Sent: 30/09/2019 2:11:10 PM
Subject: Submission to DA 0081/2019
Attachments: Letter- objection-307 Sydney Road Balgowlah4.pdf;

**Re: 307 Sydney Road & 12 Boyle Street Balgowlah - DA 2019/0081
Proposed Residential Flat Building**

Image of proposed access arrangements as presented by the applicant.

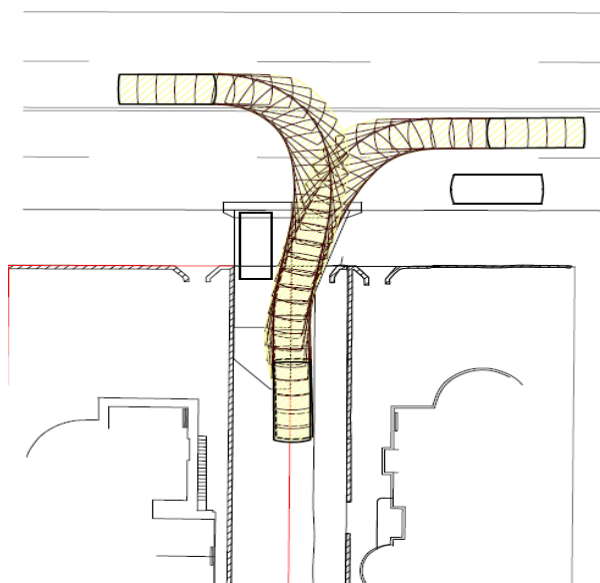
It would appear that the subject site is reliant on the adjoining site also for proper use, serviceability and access (as indicated in the diagram below sourced from the Traffic report). Without the owner's consent of adjoining property owners involved in the shared driveway, the application is incomplete and cannot be determined favourably. Please note that the owners of SP 5090 do not consent to the application.

The width of the ramp and driveway is 3m when the standard calls for 3.3m. Further a 5.5m passing area is required when the proposal presents 6.3m.

All manoeuvring is tight and highlights the compressed and overdevelopment nature of the proposal.

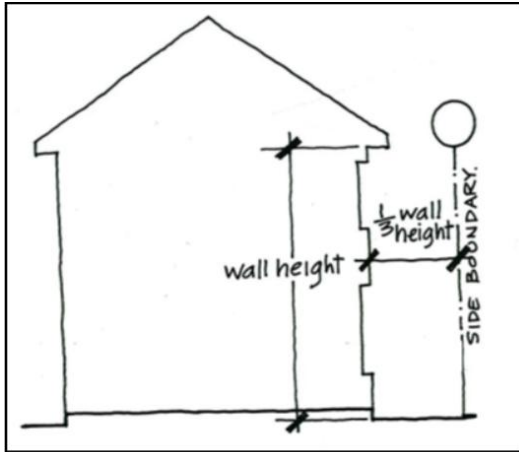
It would appear that the rear building component is setback 8m from its external wall to the southern boundary, however proposes a rear elevated balconies setback 7m from this rear boundary. It is noted that the control relates to any part of the building and accordingly a non-compliance arises. The balconies are to have a floor level 7m higher than natural ground level and the design effectively creates a cascading 'grand stand' effect of viewing potential into the adjoining susceptible adjoining dwelling at No 8 Boyle Street.

Landscaping in the form of balcony planters are ground level planting cannot effectively be relied upon by the applicant to protect the amenity, privacy and solar access presently enjoyed by the residents of No 8 Boyle Street. A sectional shadow profile should be provided by the applicant to determine the actual shadow affectation of this southern adjoining property.

Figure 32 - Wall on Boundary Provisions

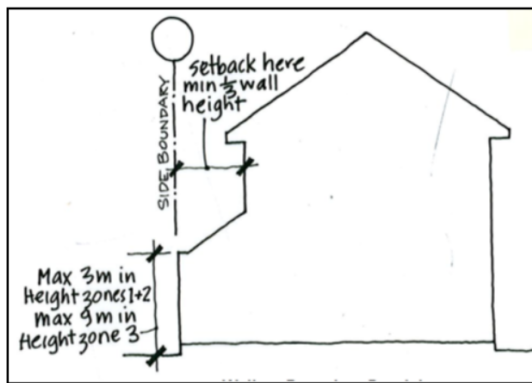
Clause 4.1.4.2 of the DCP relates to Side setbacks and secondary street frontages. The diagram below explains the means in which setbacks need to be determined.

A review of the design confirms that little regard has been given to this control with 2 storey elements sitting within 1m from side boundaries.
